Subject: Borg-Warner 3" and 4" Swing Check Valves

10 CFR PART 21 NOTIFICATION

(Reference No. CFRN-9301)

Texas Utilities, Comanche Peak Steam Electric Station.
Basic Component: 4-inch 150# Bolted Bonnet Swing Check Valve
BW/IP Part No. 75580
TU Tag Nos. 2CC-0697 & 2CC-0693

Required Angle of Disc Rotation and Axial Gap for Interference

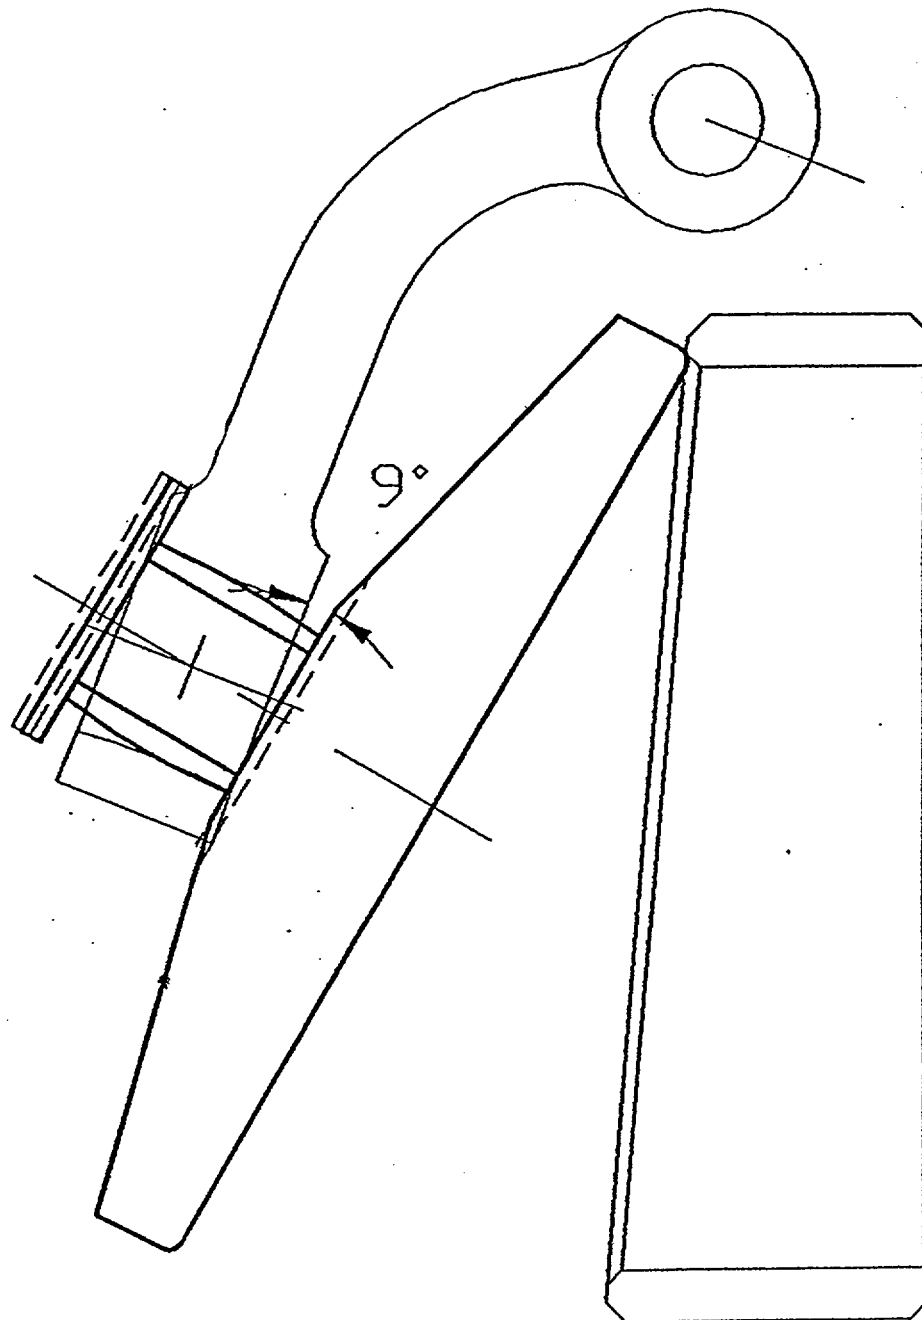
Valve 2CC-0697 did not fully close during pre-operational testing. Radiographs taken at the time of failure show the disk positioned at approximately 21° from the full closed position. The valve was disassembled. The top of the disk was found to be lodged under the seat lip preventing full closure. Valve 2CC-0693 subsequently failed testing in a similar manner. Both valves are located in the Component Cooling Water return lines from the Reactor Coolant Pump Motor Coolers and do not serve an active safety function. However the failure mechanism could apply to other valves that do provide a safety function.

Evaluation of the basic component by BW/IP indicates the root cause of the failure to close is due to the configuration of the attachment weld between the disk to the stud. Prior to 1977, this weld was placed on the back surface of the stud and extended into the bushing bore. In disks manufactured after 1977, the weld was recessed into the back surface of the disk and a final machine cut made to assure a flush surface.

This notice applies to all BW/IP 4-inch, 150#, bolted bonnet swing check valves which have a raised disk-stud retention weld on the back surface of the disk.

On May 31, 2001, Arizona Public Service Co. advised Flowserve that they recently encountered the same problem on a 4"-1500# pressure seal swing check valve. Because of this, Flowserve decided it would be prudent to notify or re-notify all customers who purchased 3" or 4" swing check valves or disc assemblies in 1977 or earlier of the potential problem. We recommend the valves be inspected at the earliest convenient time and if evidence of interference is found, replace the disc assembly. The enclosed sketch depicts the potential problem if there is excessive disc angular movement.

Corrective action is complete with the disk design modification identified above.

Licensees with valve installations effected by this notice should install a new disk component or refurbish the existing disk.
